# Access Compliance Report Public Rights-of-Way (Curb Ramps)

| Main Street: SOL_ST                     |                                  | Cross Street: ETHEREAL_RD |                                         | Location:       | E  |
| ADA ID: RPRK211104125519                | Ramp Type:Type 1 - Perpendicular | Initial Pass/Fail: Fail   | Overall Compliance: No                  | Severity Score: | 15 |

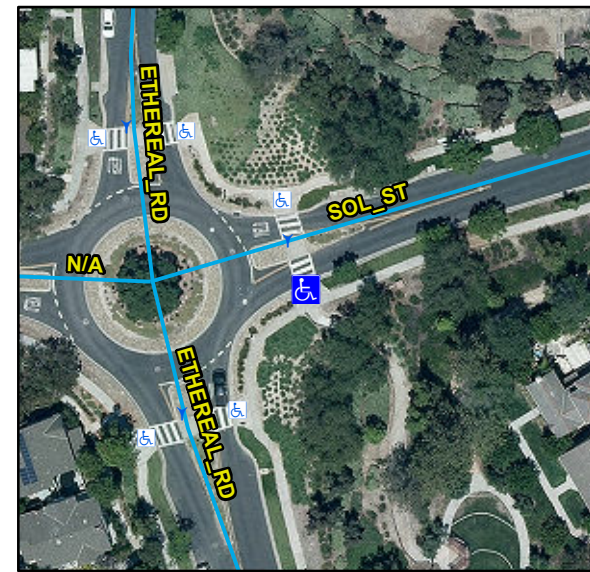
| Compliance | Description                           | Data | Compliance | Description                   | Data |
|------------|---------------------------------------|------|------------|-------------------------------|------|
| No         | Ramp Run Slope (%)                    | 9.2  | N/A        | Flare Slope LT (%)            | N/A  |
| N/A        | Gutter Ponding                        | N/A  | No         | Curb Slope                    | 7.5  |

Possible Solutions:

Remove & Replace Entire Ramp.

R304.2.2, R204.3, STD 1115
